SERVICE LETTER NUMBER 143			
TITLE: MAIN LANDING GEAR PROXIMITY SWITCH			
BY: S. ST. JACQUE	AIRCRAFT MAKE/MODEL(S):  N/A	FLOAT MODEL(S):  2100, 2350	NOTE(S): MANDATORY COMPLIANCE <b>S/L P/N 1005934</b> <b>ECO 23719</b>
APP: C. WOKEN			
DATE: 07/30/14			
REV: B

FAA APPROVAL HAS BEEN OBTAINED FOR TECHNICAL DATA IN THIS PUBLICATION THAT AFFECTS STC OR TSO DESIGN COMPLIANCE

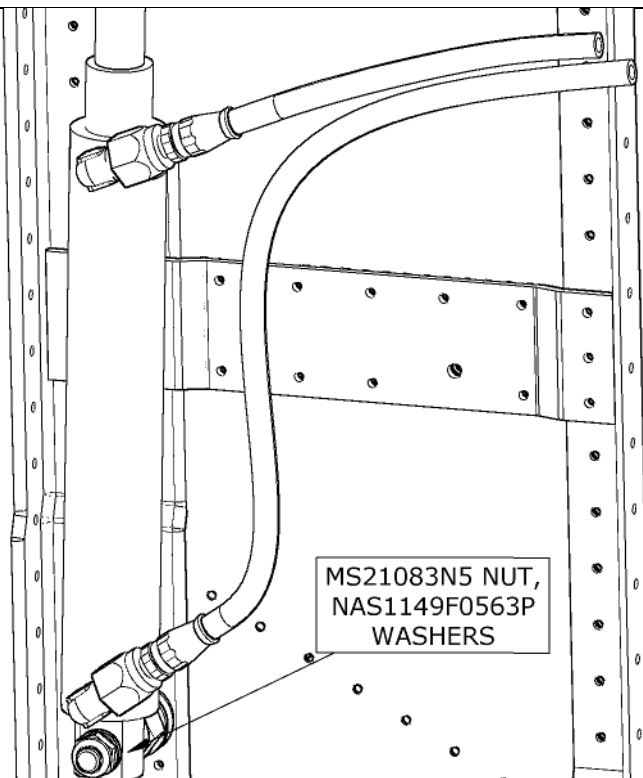
6. Locate and label the Proximity Switches “Upper” and “Lower” to help identify later. Remove 21A09005-262 Clips for both upper and lower Proximity Switches.

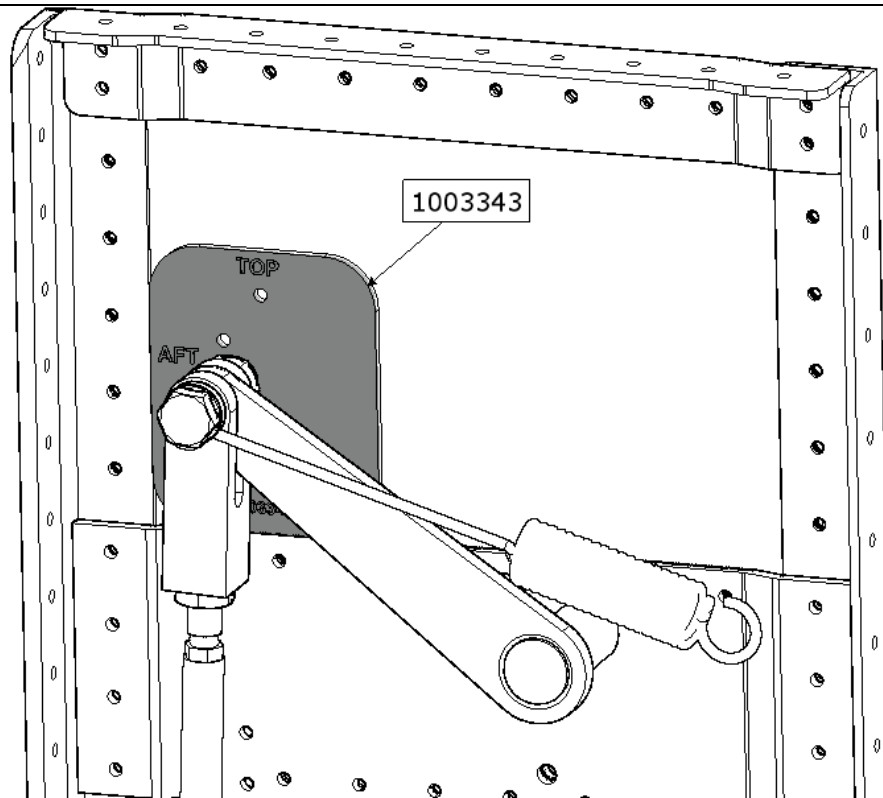
7. Discard 21A09005-262 Clips and attach hardware. Leave the Proximity Switches attached to the wiring harness as they will be reused in new location. Remove MS21083N5 Nut and NAS1149F0563P Washers and set aside to reinstall later. Do not remove Hydraulic Actuator.

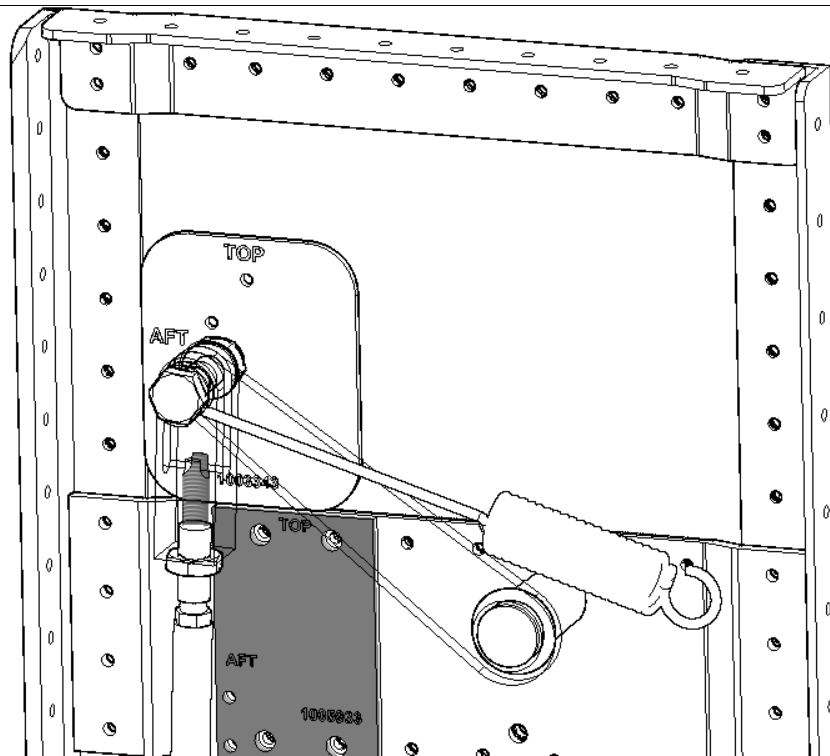
8. Locate and install the 1003343 Switch Doubler. Position 1003343 against Side Gear Panel components as shown and match drill through (2) #30 holes into Side Gear Panel. Deburr holes. Use PR-1422 B-2 Sealer or equivalent between Doubler and panel. (no rivets)

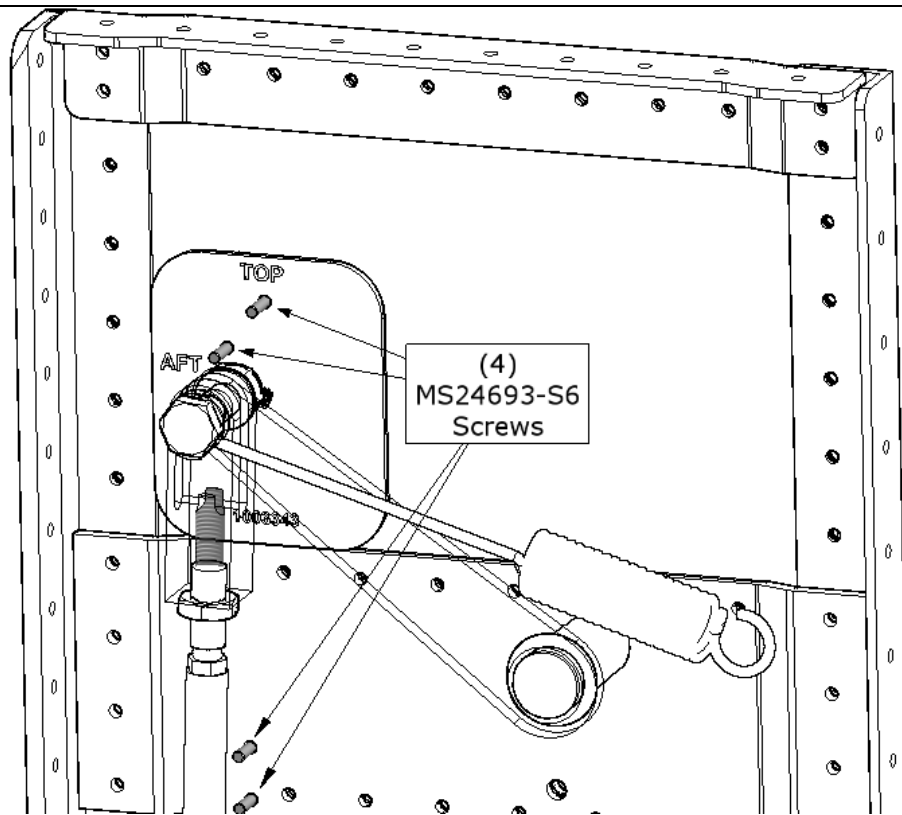
9. Position 1005933 Drill Template as shown. Drill (2) #30 holes through panel using drill template as a guide. Remove and discard 1005933 Template. Remove and double flush the lower rivet that is closest to the joggle.

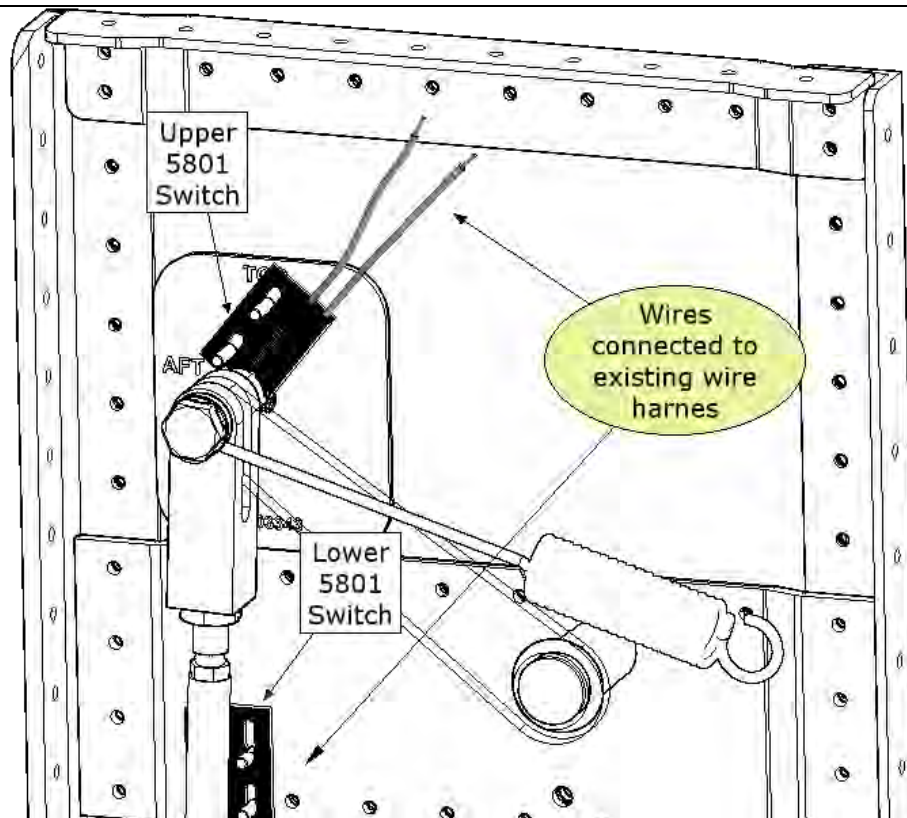
10. Countersink the backside of (4) new holes to fit flush MS24693-S6 screw. Install (4) MS24693-S6 Screws wet with PR-1422 B-2 or equivalent sealer.

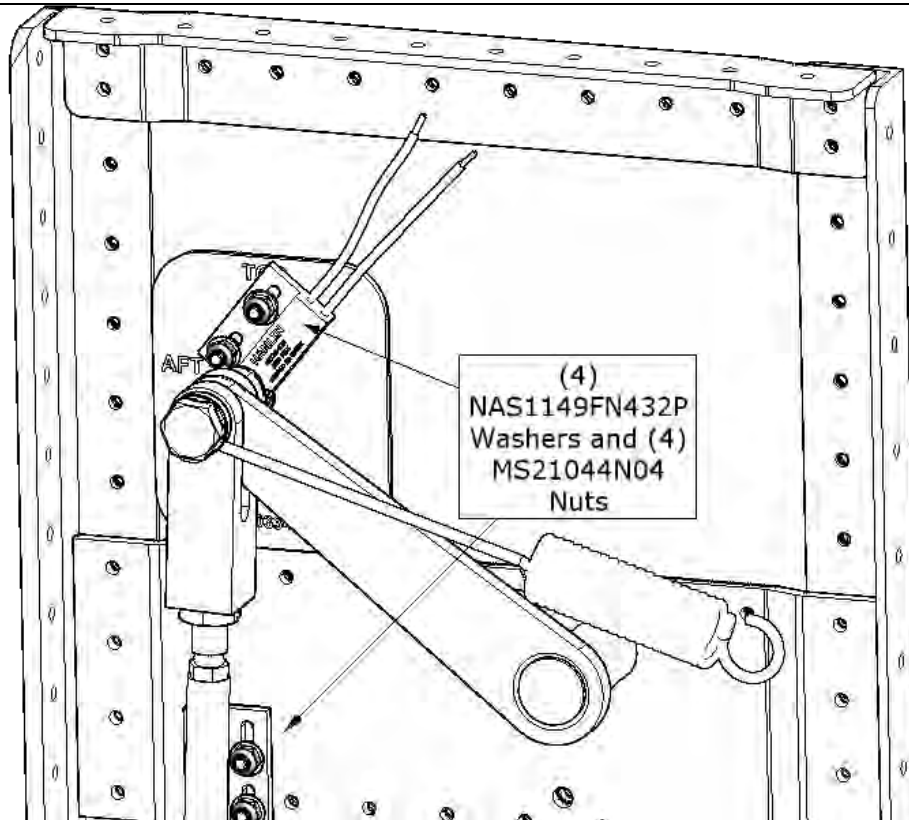
11. Position the 5801 Proximity Switches. Be sure to locate the Upper switch on the upper attach point of the panel and Lower switch on the lower attach point.

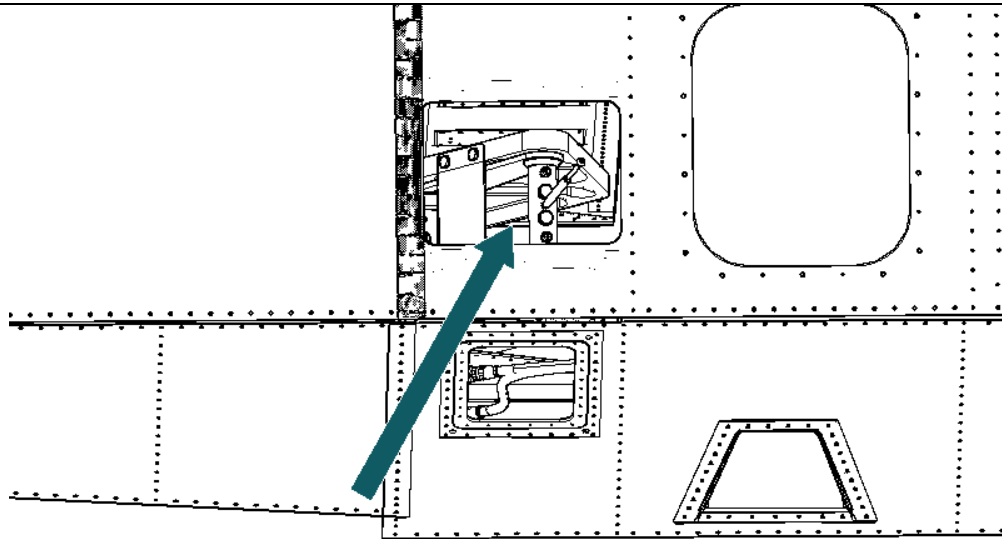
12. Add (4) NAS1149F032P Washers and (4) MS21044N04 Nuts.

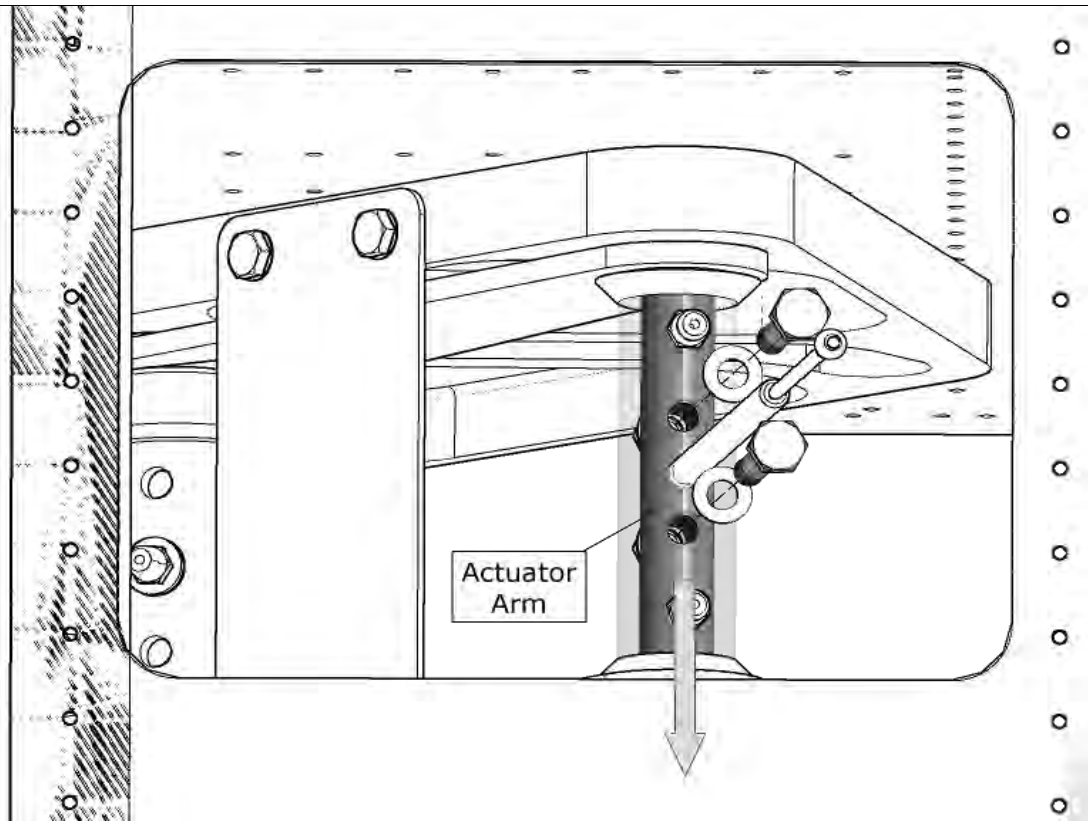
13. Locate and remove Top Access Cover to expose Main Gear. (View: Top and Outboard side of right Float)

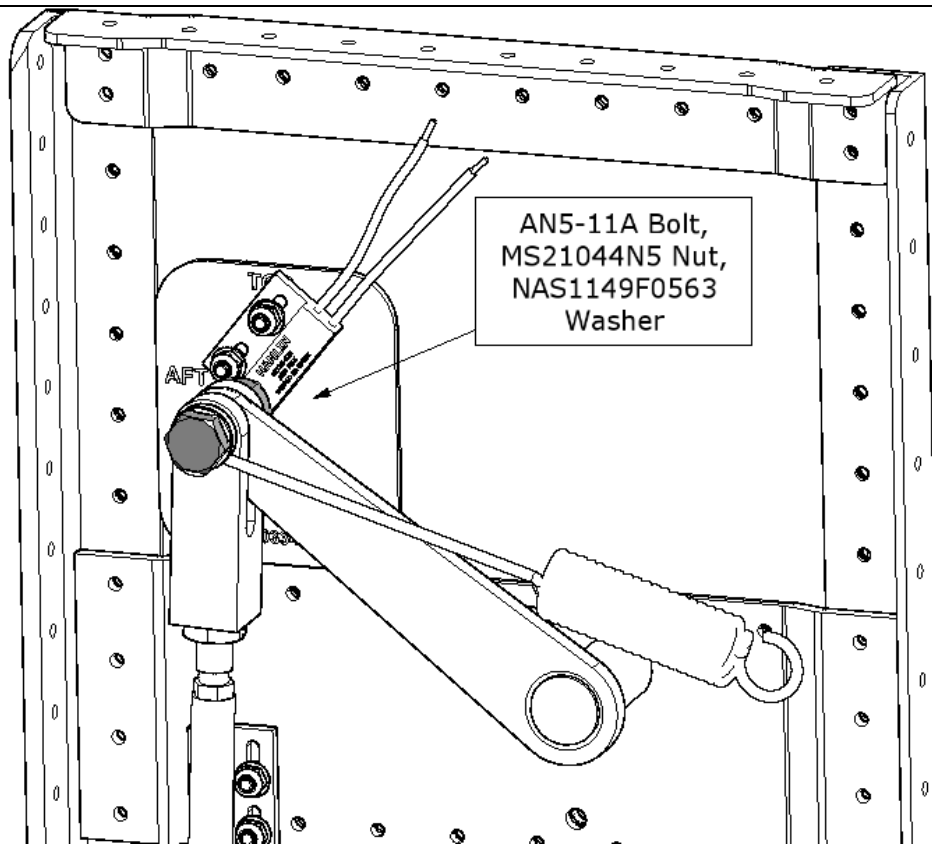
14. Remove (2) NAS6204-17, (4) NAS1149F0432P Washers, and (2) MS21044N4 Nuts. Keep hardware to reinstall later. Actuator Arm will slide in direction to aid in steps that follow.

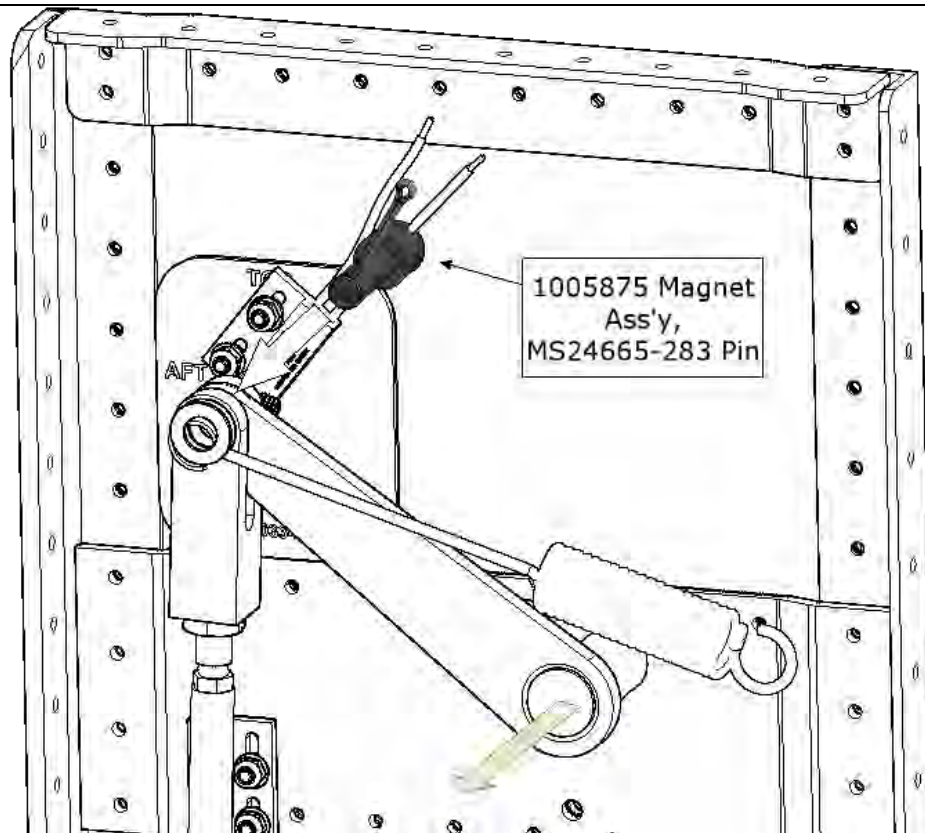
15. Remove AN5-11A Bolt, MS21044N5 Nut and NAS1149F0563 Washer and discard the Bolt and Nut only. (View: outboard side of right Float)

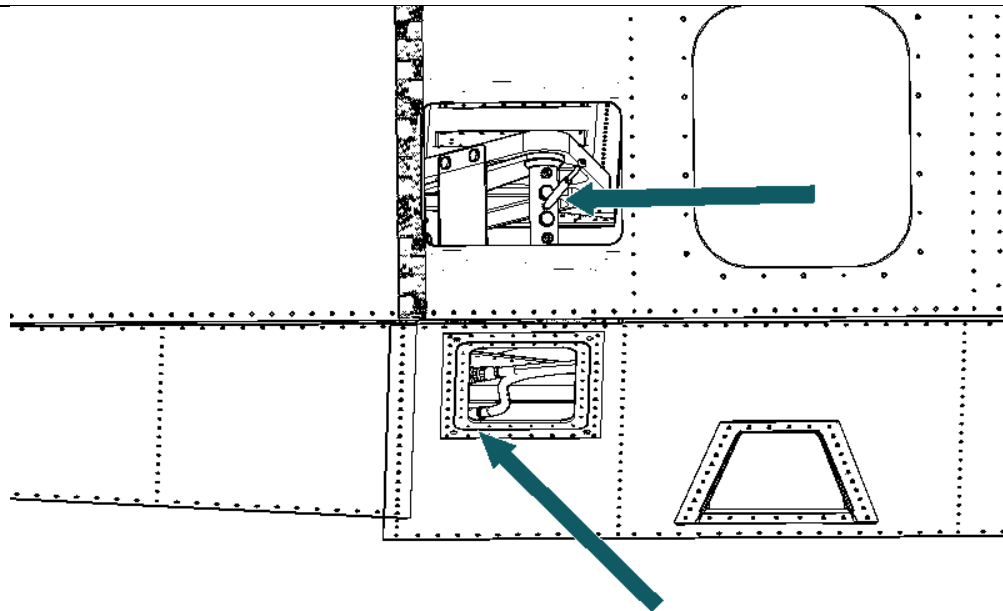
16. Replace with 1005875 Magnet Assembly and secure with MS24665-283 Cotter Pin. Pull Actuator Arm in direction shown to allow extra room to install 1005875 Magnet Assembly.

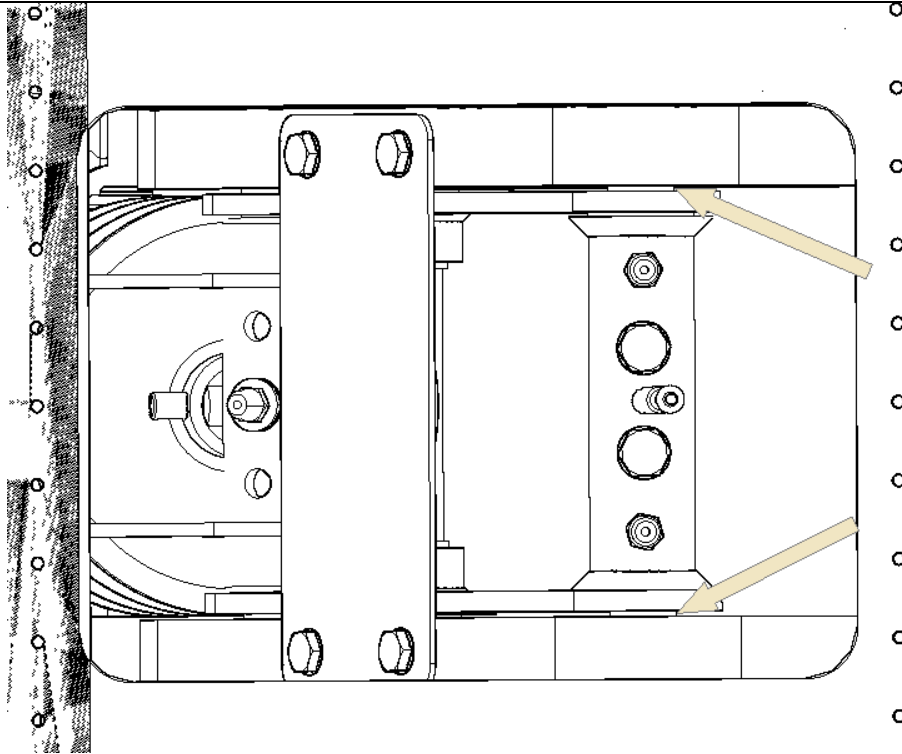
17. Reinstall Hydraulic Actuator and Actuator Arm mount hardware. (View: Top and outboard side of right Float) As needed, use Ø5/8" Washers as spacers to reduce slop between Side Plates and Main Gear NAS1149F1032P on outboard side, and NAS1149F1063P on inboard side .

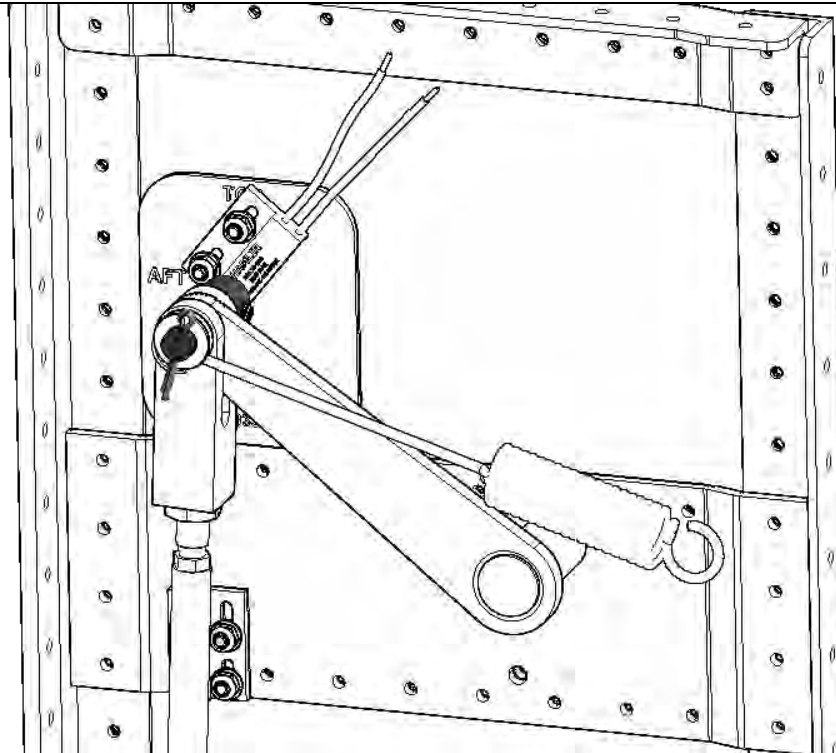
18. As needed, install Washers (NAS1149F1032P and NAS1149F1036P) as spacers to reduce slop between Side Plates and Main Gear. Must move freely!
